2016SYE109 – 17-23 Mitchell Avenue & 78 Sutherland Road Jannali

DA16/1239

ASSESSMENT REPORT APPENDICES

Figure 2: Section 1

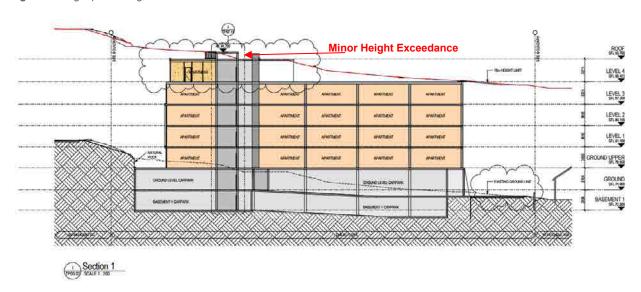
The proposal has been amended to reduce the building mass and maximum building height. Level 4 of the building has been reconfigured to remove the northern eastern portion of the building. As demonstrated in the height plane diagram below (Figure 1), the development as now proposed includes only minor elements which protrude above the maximum building height including the southern lift overrun. The projection above the 16m height limit is also indicated in Sections provided at Figure 2 and 3.

SECTIONS 1 and 2

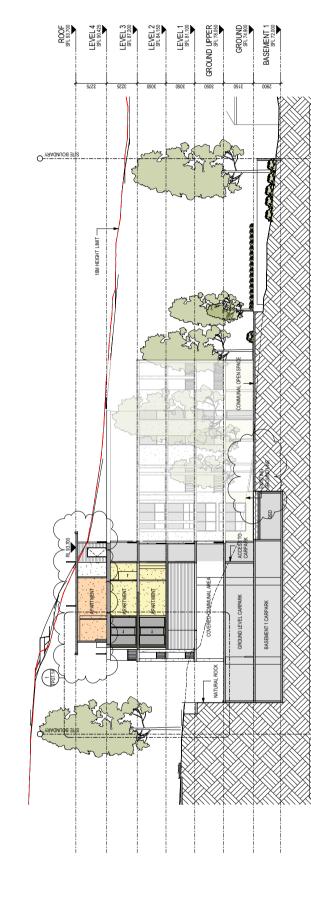
BBQ PAVILION AREA DELETED SECTION 1 LEVEL 4 APARTMENTS REPOSITIONED SECTION 2 LEVEL 4 APARTMENTS REPOSITIONED

NOTES:
EXISTING GROUND LINES ADDED

SHADOW DIAGRAMS - JUNE 21st | TP04.01 | A

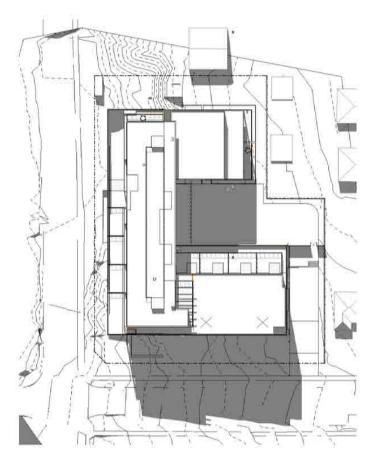
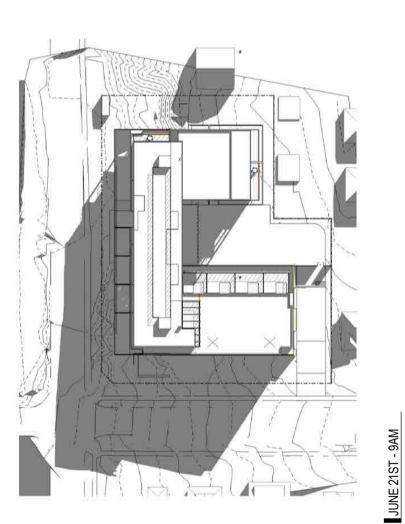
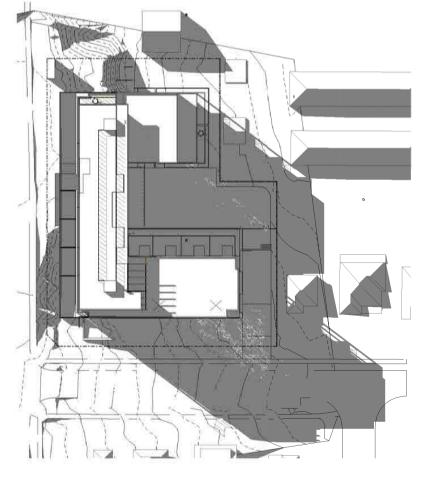
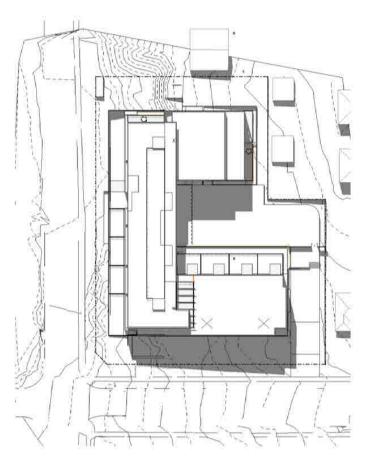
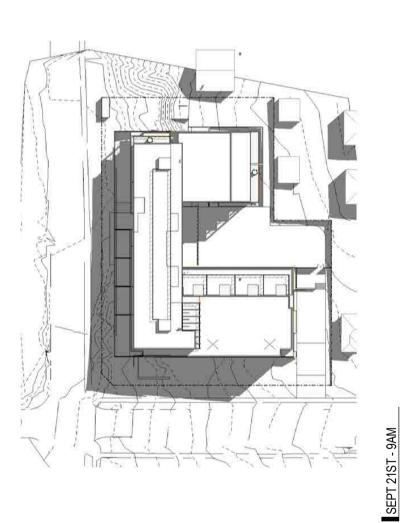
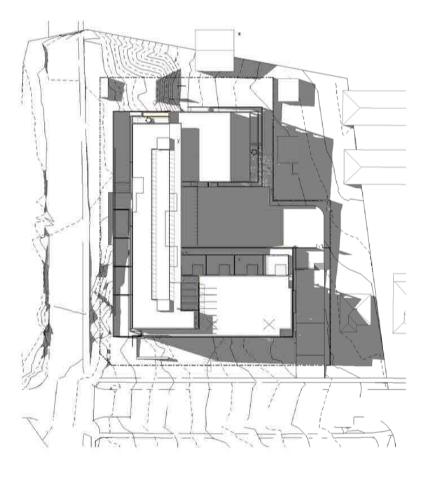
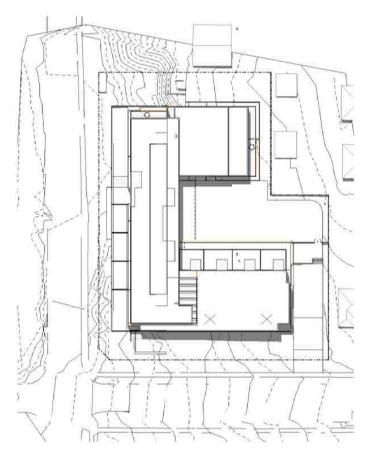
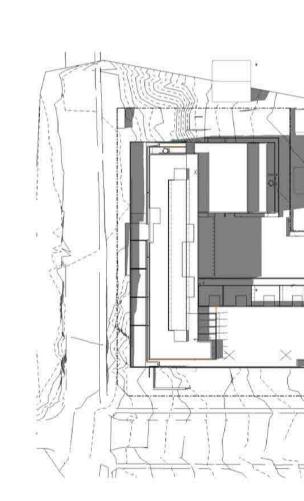
NOTES:
DIAGRAMS EXTENDED TO SHOW
FULL EXTENT OF SHADOWS

NOTES:
DIAGRAMS EXTENDED TO SHOW
FULL EXTENT OF SHADOWS
